La Marzocco Technical Bulletin #105

New GS3 Displays and Firmware

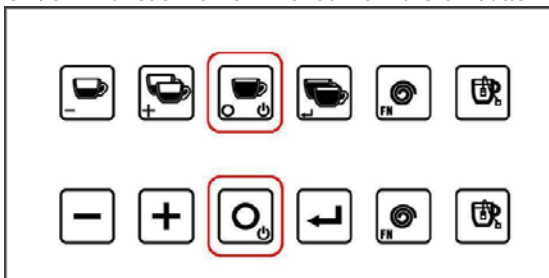
This bulletin is to inform you of some improvements La Marzocco has made to the GS3 displays. The improved button configuration is as follows:

ON/OFF function is now moved from the 6th button to the 3rd:

The new displays and keyboards will work only with new firmware versions: AV - 3d5LuFam_116
